QGC Upstream Holdings Pty Ltd

Information Request Response – Amendment of Environmental Authority EPPG00700113 (Surat Basin Acreage Development)

ATTACHMENT 1 – RESPONSE TO INFORMATION REQUEST

Figure 1 – Brine forecast

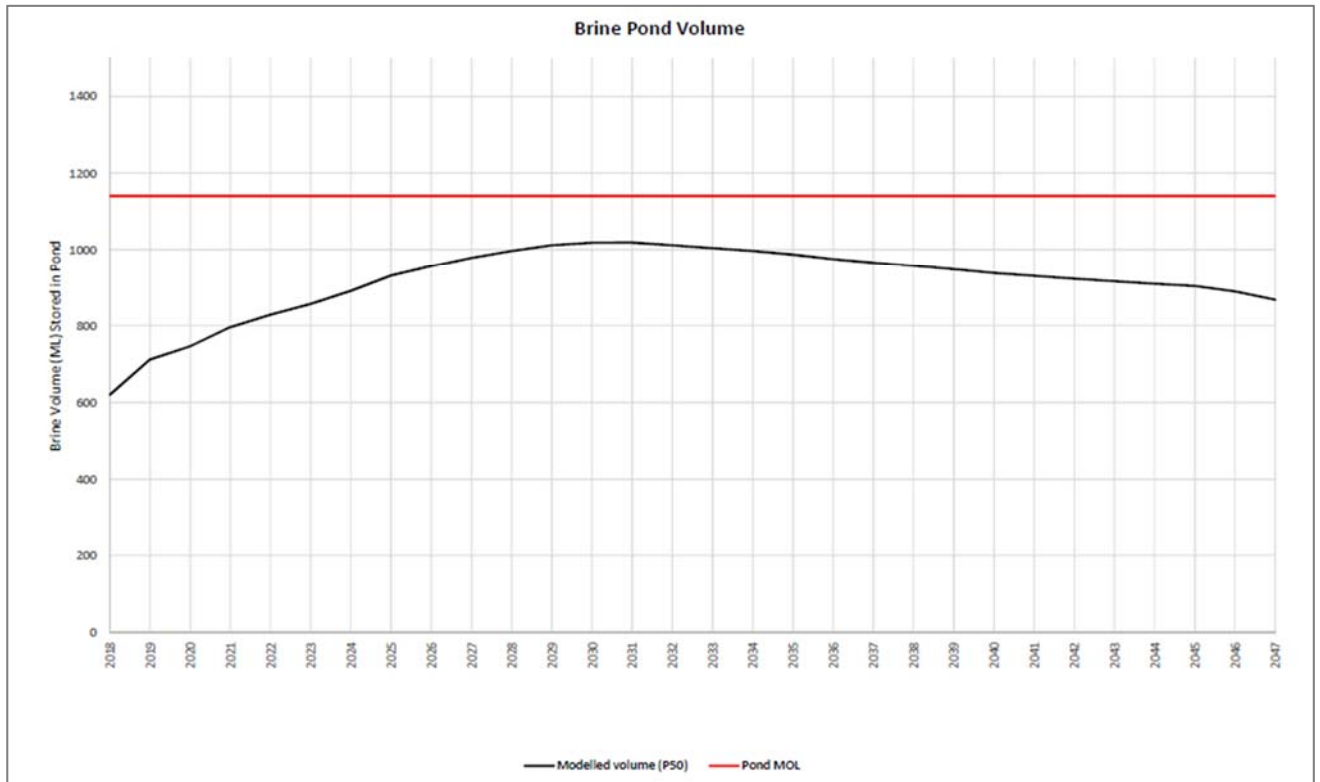
- 5. Confirm the annual quantities of brine expected to be generated by the entire activity (existing and proposed). Confirm that sufficient capacity exists in the Woleebee Creek brine dams to contain this additional volume of brine from the proposed project, as well as being able to contain any reasonably foreseeable rainfall events. Provide further advice as to how QGC will address the increasing volume of brine generated by this activity over the lifespan of the project. Provide further advice as to how QGC intend to dispose of the brine generated from CSG activities.***

The forecast total brine storage over the life of the entire activity (existing and proposed) is shown in Figure 1 below. It should be noted that this is an approximate volume and is based off a modelled water production forecast (P50), which can vary depending on how the development of the wells are brought online and operated, but is considered a reasonable estimate.

QGC runs complex water modelling software to determine expected water flows through the entire water cycle i.e. from Infield Storage Ponds / Regional Storage Ponds, through the Water Treatment Plant and into the treated water outlets (Sunwater Pump Stations) and brine storage ponds. Current modelling indicates that there is sufficient capacity within all existing water infrastructure, including the brine storage pond at Woleebee Creek, for current and proposed flows. A variety of scenarios are run, including average climate data and higher rainfall scenarios. The concentrated brine storage pond, like all regulated water storages, requires provision for high rainfall events.

Figure 2 – Produced water volume forecast

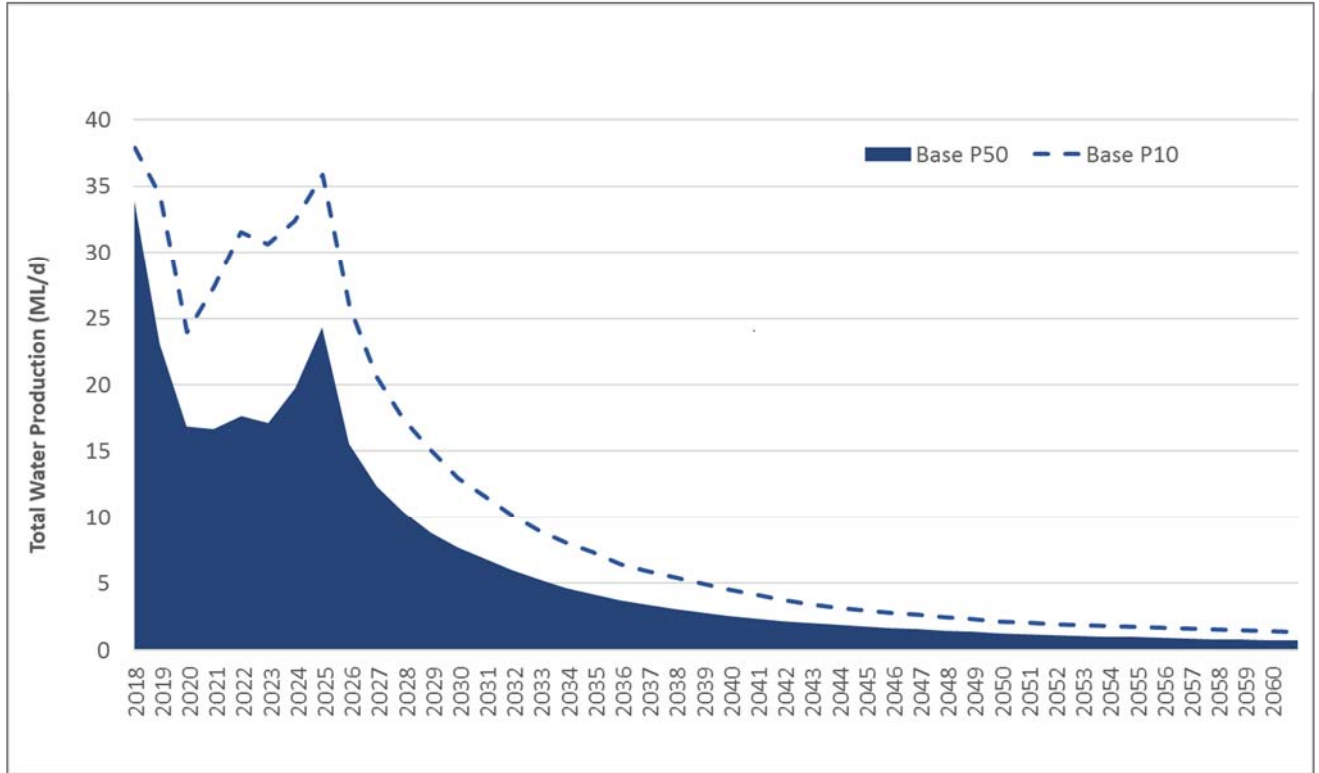
6. Confirm that the increase in volume of material directed to the Woleebee Creek water treatment plant will not exceed the current daily limit of 100ML on the existing EA?

Confirmed. QGC’s current and forecasted water production rates for the additional wells to be drilled within the Surat Basin Acreage area are significantly lower than previously anticipated. As shown in Figure 7-2 of the application, the maximum predicted water production rate from the proposed wells would be

approximately 23 ML/day. Figure 2 below shows QGC's modelled produced water volumes output (both P50 and P10) from wells within the Project area which are processed through the WTP.

The data presented shows a P50 water production volume that remains generally below 20 ML/day, with a gradual decline over the life of the asset. Water production has been significantly less than originally anticipated and is expected to decline (even with the additional wells proposed).

By comparison, QGC's WTP and associated water network has a design capacity of 100 ML/D which is far in excess of current and future requirements.

ATTACHMENT 2 – IMPLEMENTATION OF THE PROTOCOL

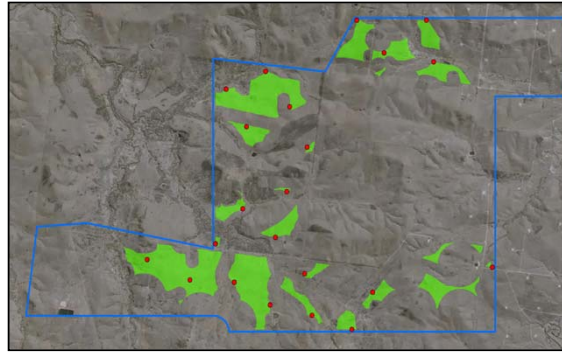
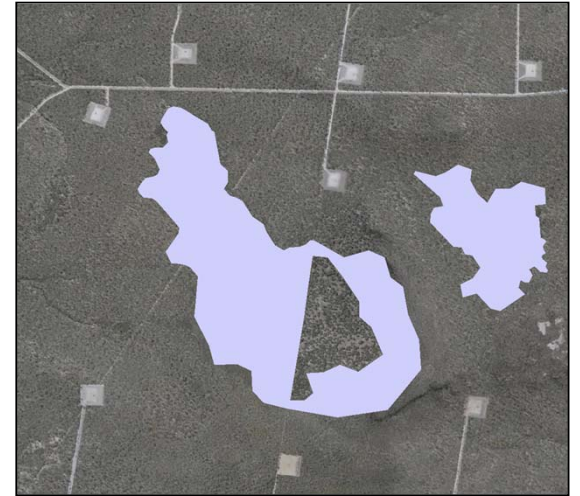
2. Demonstrate where areas where ecosystems and species that are determined to be of greater environmental value, or at greater risk from disturbance, have been completely excluded from any proposed development.

- The figure above shows an example property/development phase from within QGC's Project area.
- In accordance with the relevant tenure instrument (e.g. a Petroleum Licence issued under the P&G Act) and Landholder Agreement, QGC has access to the entire property to undertake its activities.

- In accordance with QGC's Constraints Planning and Field Development Protocol, a series of constraints and development rules are applied to the site.
- This is an automated process that applies predetermined rankings and/or rules of development to a range of identified constraints.
- Examples of constraints at this stage include, but are not limited to, environmental (e.g. MSES), cultural (e.g. heritage finds), landholder (e.g. cropped areas), legislative and/or existing permit (e.g. setbacks from waterways) requirements.
- The figure above shows the remaining available areas in red.

- Next, further constraints resulting from existing surface developments are removed.
- Once again, this is an automated process.
- Examples of constraints identified at this stage include, but are not limited to, existing mine plans, existing aboveground infrastructure, etc.
- The figure above shows the remaining areas available for development yellow.

- The next step involves the development of a separate layer that identifies existing sub-surface constraints.
- This automated process takes into account all existing surrounding development activities (more specifically, their impacts below ground) as well as known geo-physical constraints.
- Examples of matters considered by this layer include, but are not limited to, drainage/ depletion of gas reservoirs from existing wells, locations of known sub-surface faulting, and results of strata permeability studies.
- The figure above shows this separate layer in blue.

- In the final automated stage, the yellow area is intersected with the blue layer, resulting in the green area shown in the figure above.
- This green area represents the available areas in which well development can be considered by QGC once above and below ground constraints are taken into consideration.
- Proposed well locations are automatically distributed throughout this final development area using an optimised well spacing algorithm. These are represented by the red dots in the figure above.

- The identification and placement of QGC well infrastructure to this point has been largely automated, and planned at a development phase scale (often involving multiple properties at once).
- The subsequent steps in this process are undertaken by specialist QGC personnel and at an individual well scale.
- An individual well has been used to demonstrate these final stages in QGC's well placement process.

- The proposed well above was automatically located by QGC's well placement tool.
- It has been placed outside of all mapped/ modelled above ground constraints (represented by the purple areas in the figure above).
- Despite this, the well was placed in a location featuring a small community of scattered vegetation.

- As part of a peer desktop review process, the location of the well was shifted north-east from its original location.
- This new position optimised it's relative positioning amongst other surrounding wells (not shown – out of frame) so as not to detrimentally impact on total reservoir depletion and drainage models.

- During field ground-truthing and survey activities, it was identified that if the proposed well location was shifted a further 80 m east, the well pad could be feasibly constructed in an existing cleared area and would not result in any impacts to existing vegetation.
- The well was subsequently shifted and developed as shown in the figure above, resulting in impacts to the scattered vegetation to be avoided.
- Other previous examples of where QGC has been able to avoid impacting on ecosystems and species of environmental value are provided in the following aerial figures.
